Agenda
City of Springboro Planning Commission Meeting
Wednesday, April 10, 2024, 6:00 p.m.
Council Chambers, City Building, 320 West Central Avenue

Background Information & Staff Recommendations
City of Springboro Planning Commission Meeting
Wednesday, April 10, 2024, 6:00 p.m.
Council Chambers, City Building, 320 West Central Avenue

- STORMWATER MANAGEMENT BASIN
- OPEN SPACE MAINTAINED BY HOA
- PROPOSED WALKING PATH
- PROPOSED PHASE LINE
- PROPERTY LIMITS

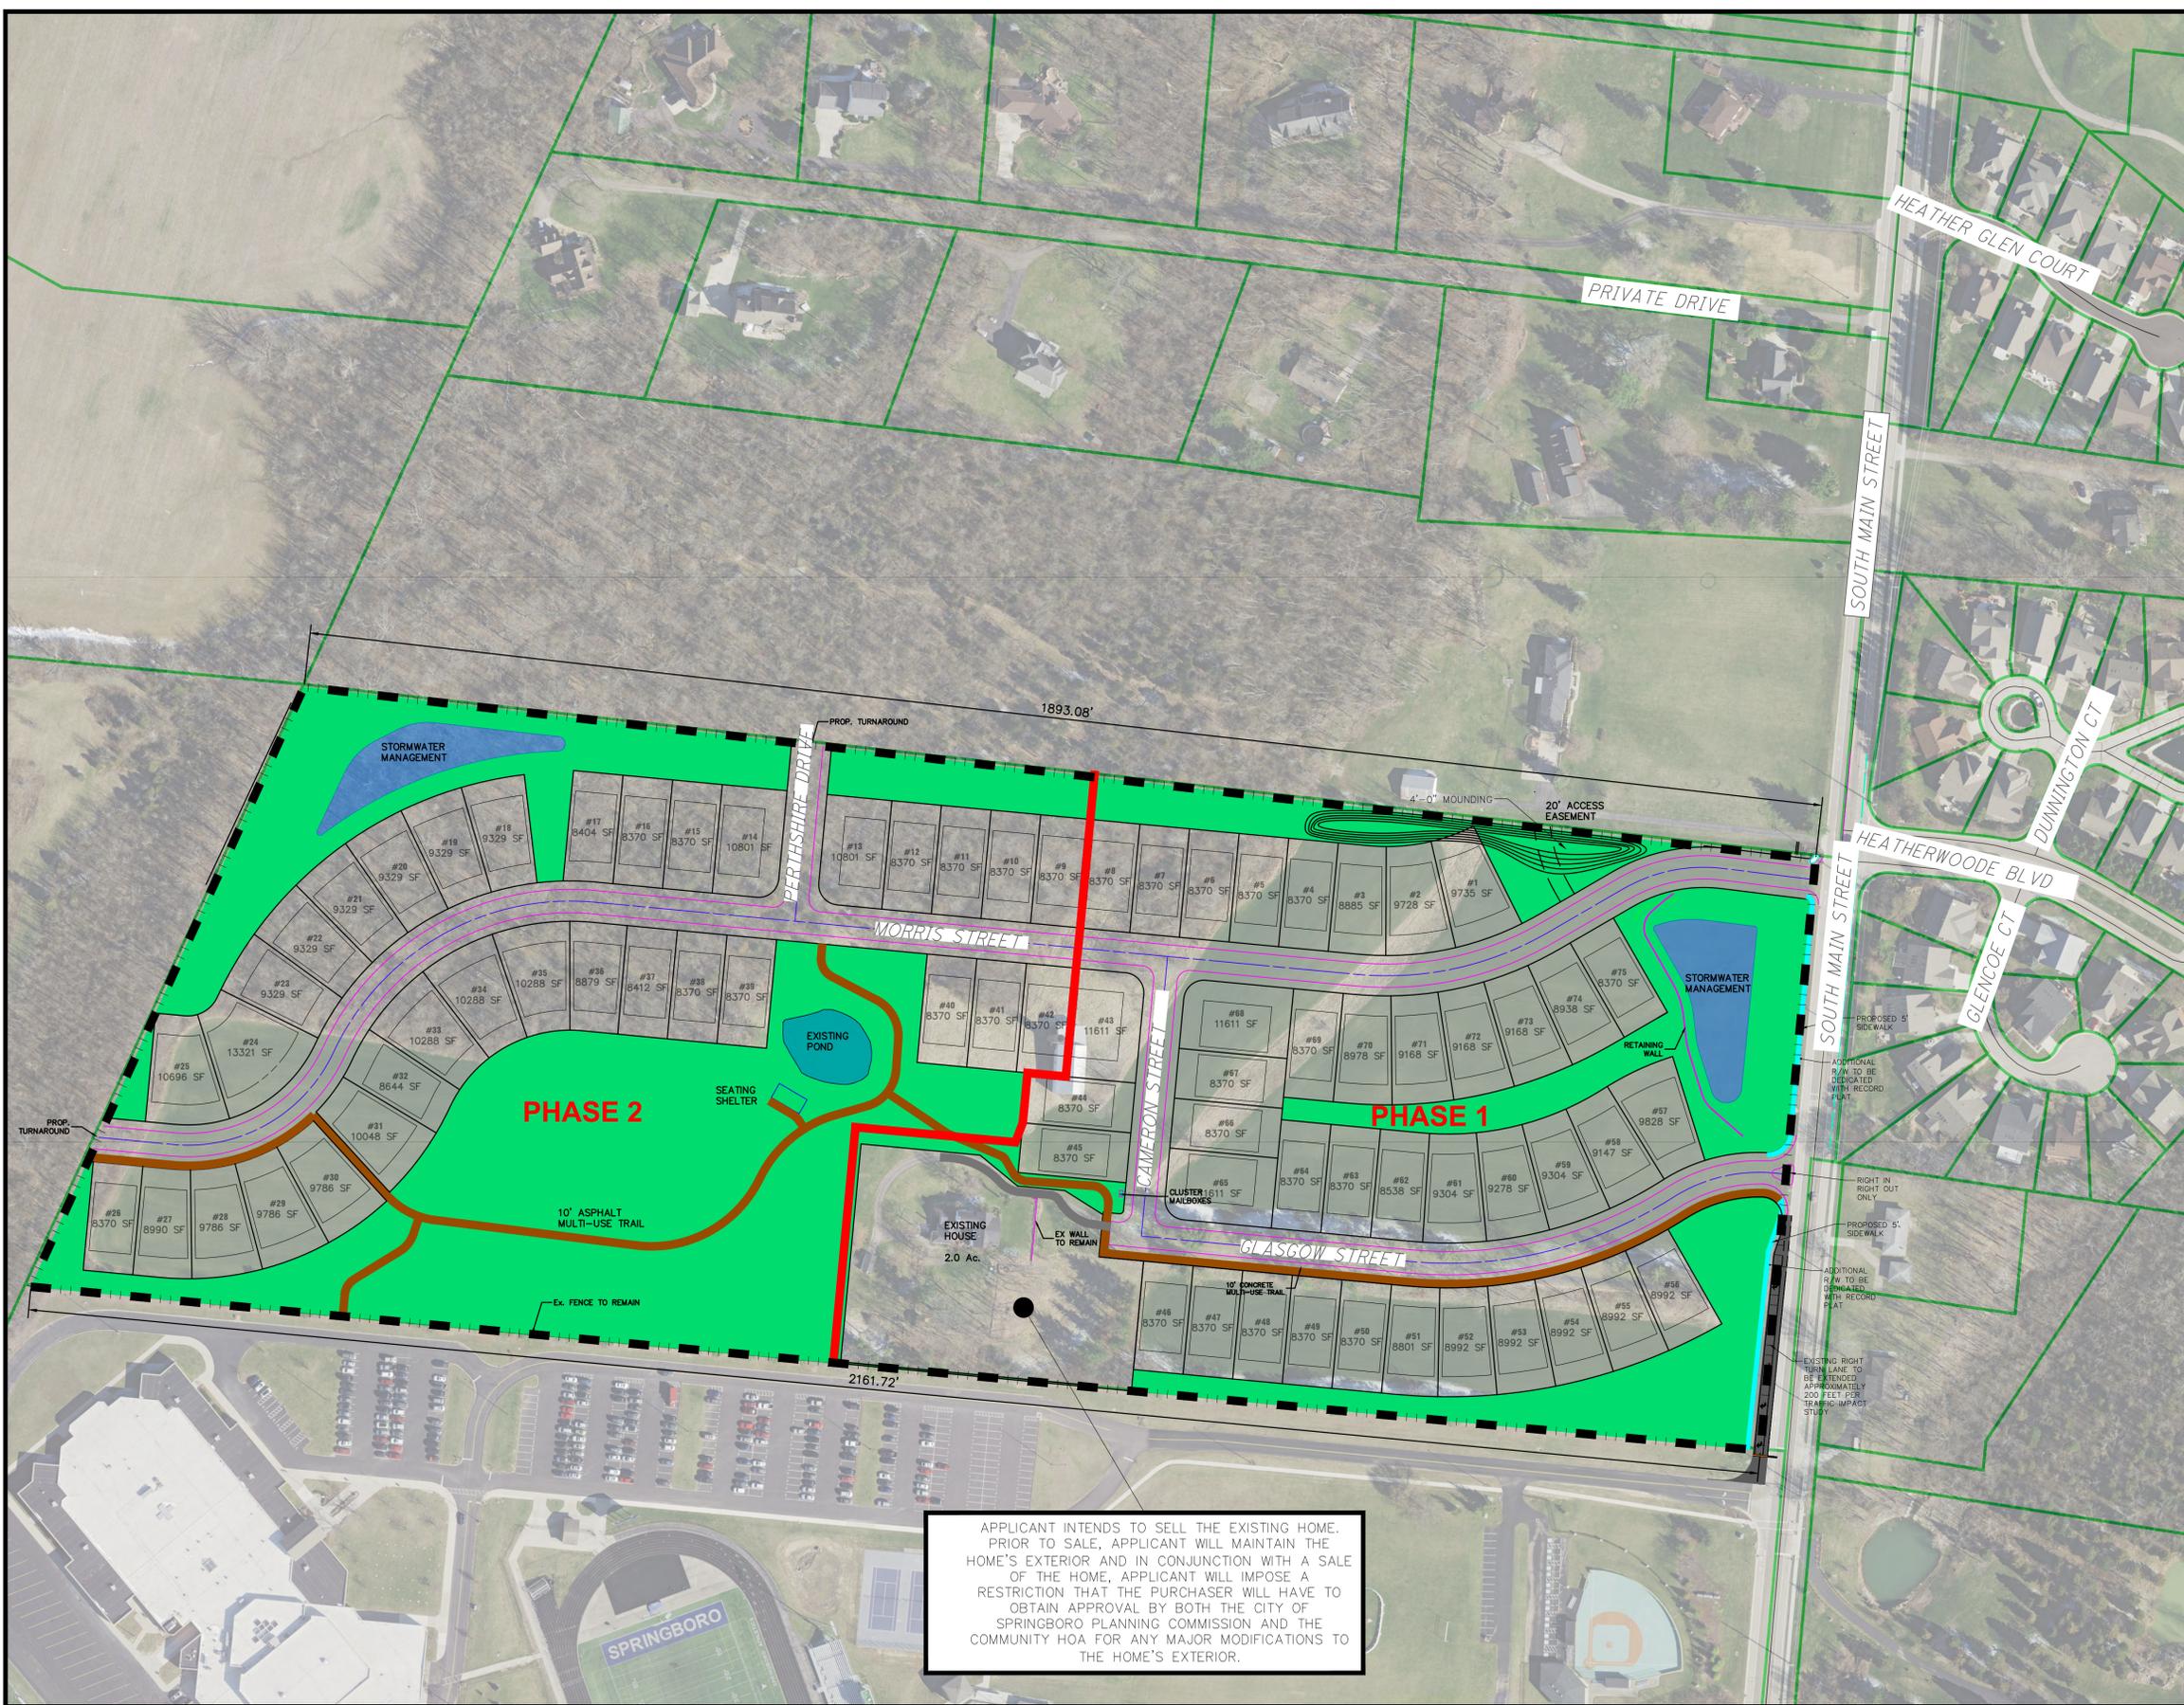
1. Check open space information provided on sheet 4 of 12; total is less than approved general plan, and the numbers do not add up correctly.
2. All homes to be consistent with Section 1264.06, Development Standards for Specific Uses, Single-Family Dwellings (Detached) for compliance of some of the home plans with (b) Appearance, and (c) Garages with respect to 60% maximum width and side/rear access.

16. Is the fence on the south property line remaining in place?
17. Provide minimum dwelling unit floor area and minimum lot size (change from typical) and delete average lot on general plan sheet 4 of 12.

FILE NAME	TREES
DRAWN BY	RJL
CHECKED BY	RJL
PROJECT No.	WANSPR12303
DATE	03-22-2024
SHEET NUMBER	8 OF 12

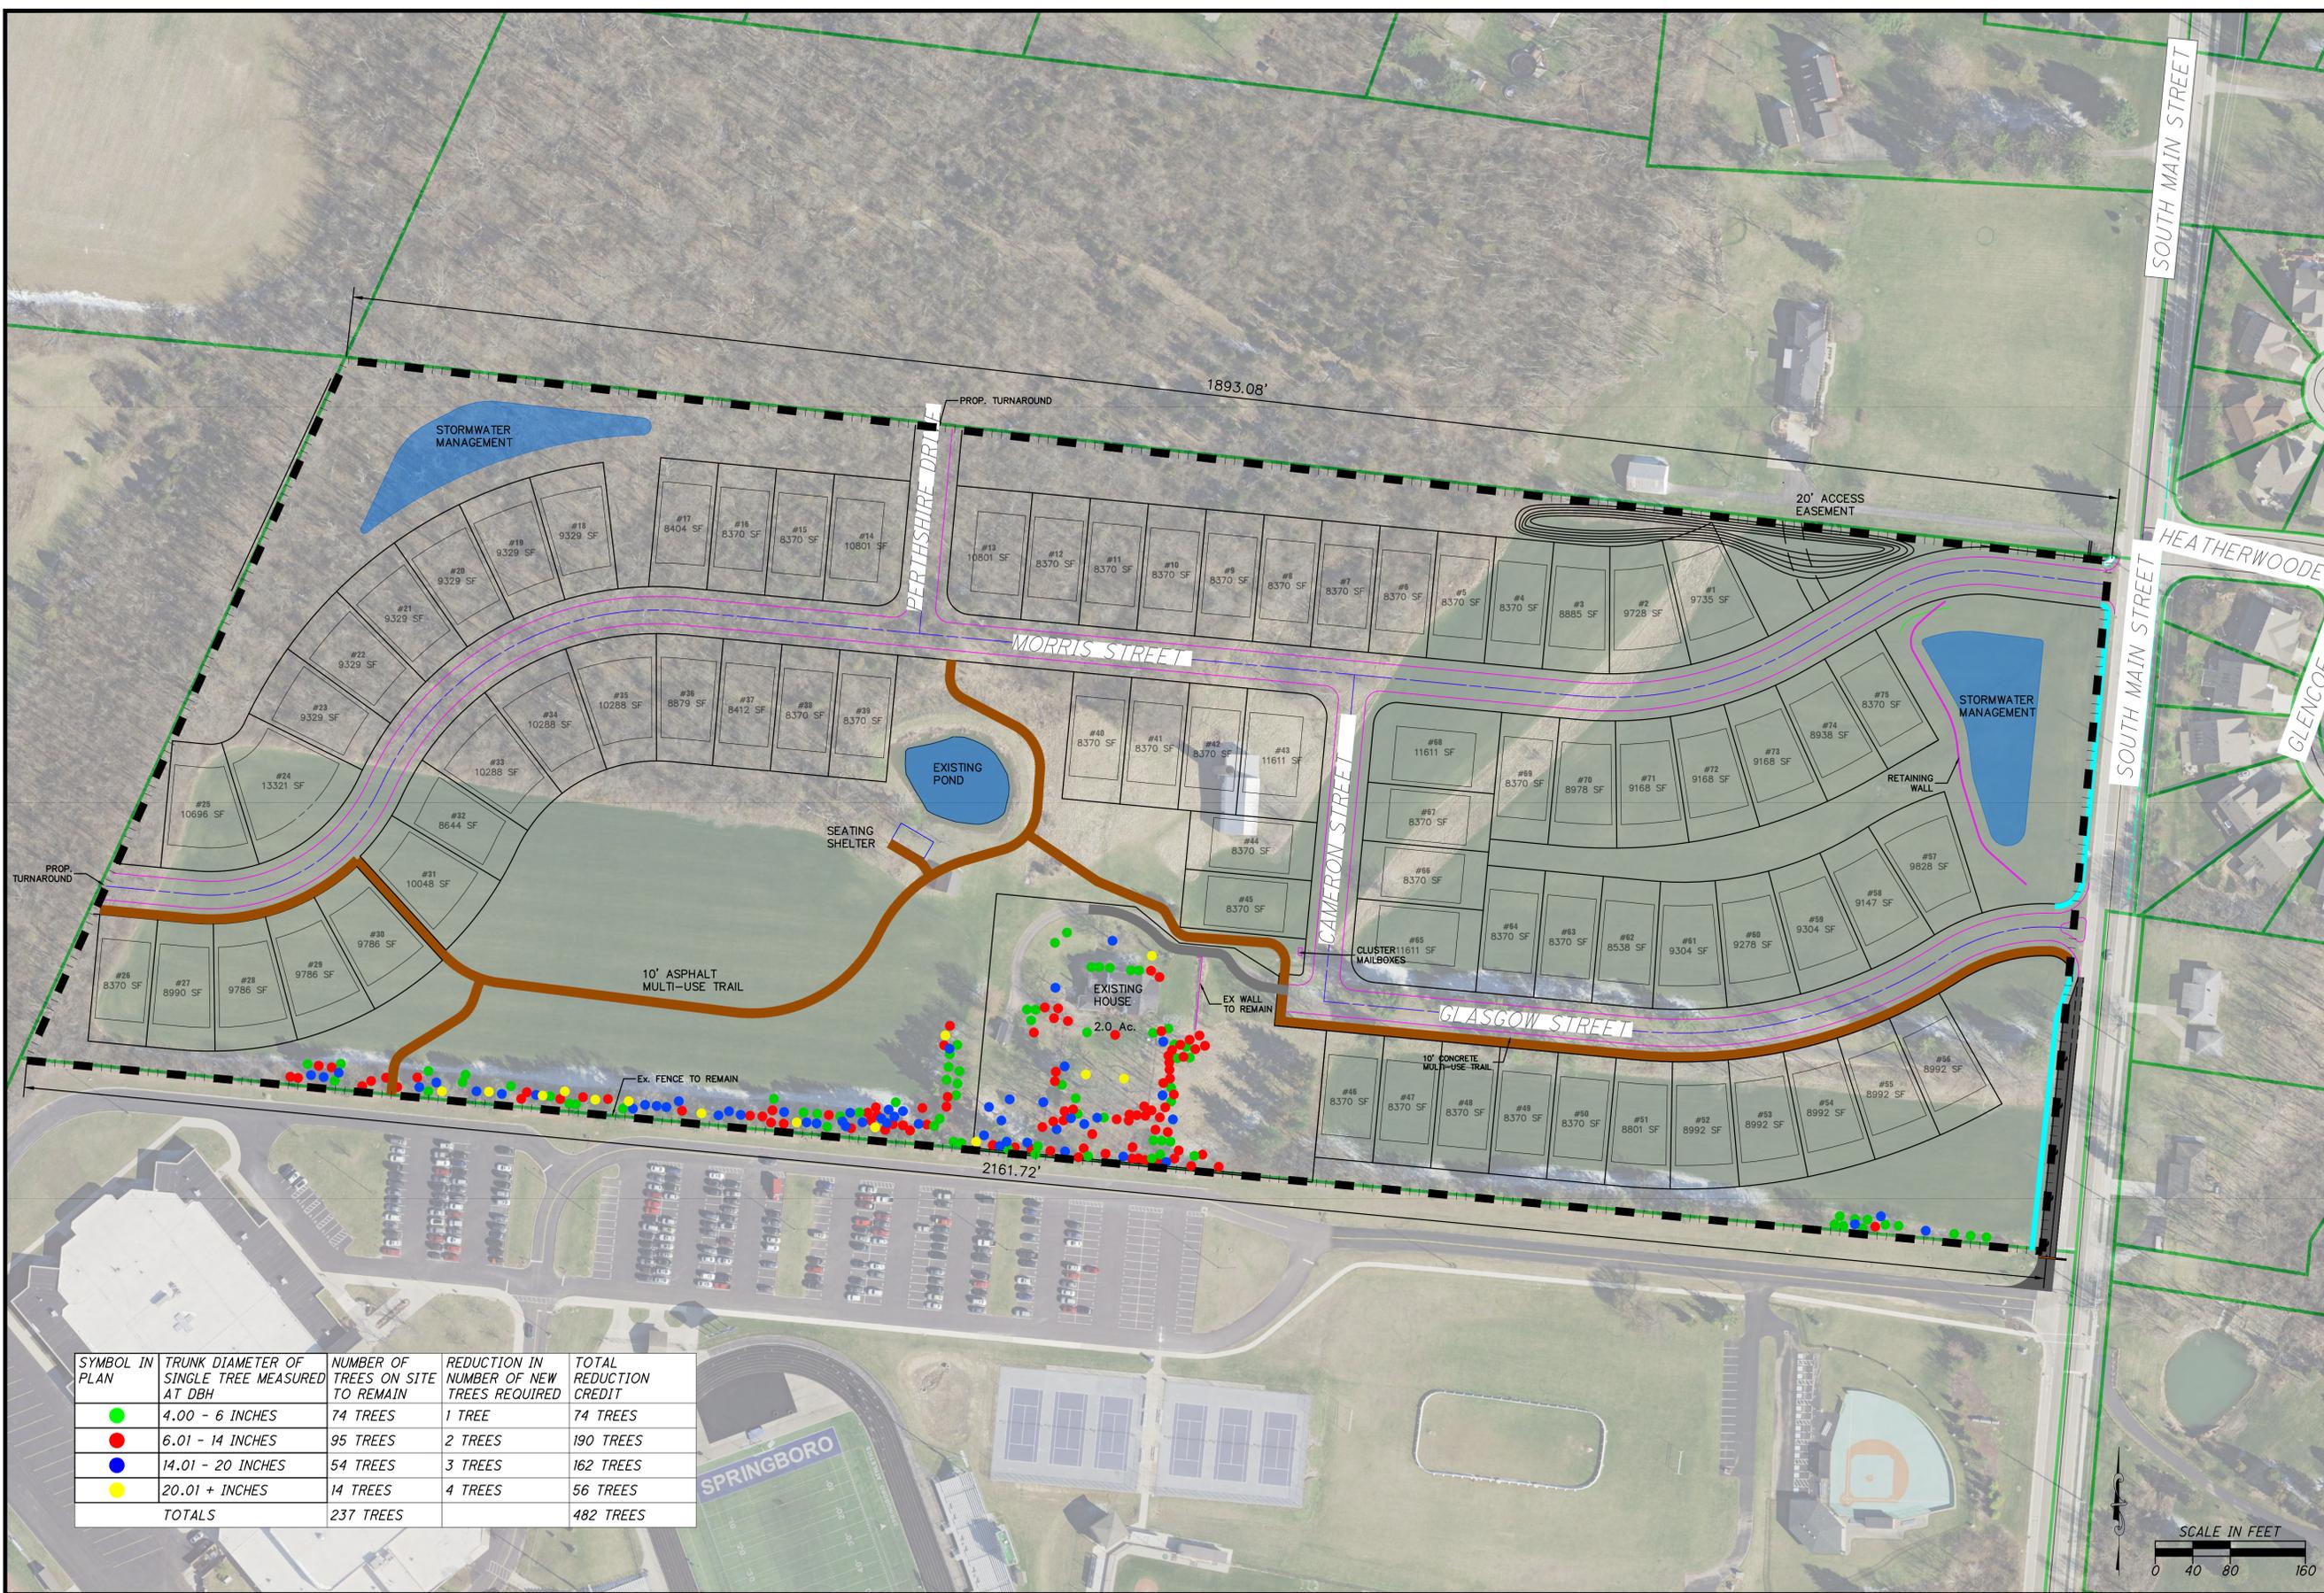
- a. Existing trees identified on sheet 10 of 12 account for an equivalent of 482 trees. Applicant to commit to those trees maintenance through the construction phase of the subdivision. These trees may be used against landscaping deficiencies in the plan except for street frontage and lot landscaping requirements.
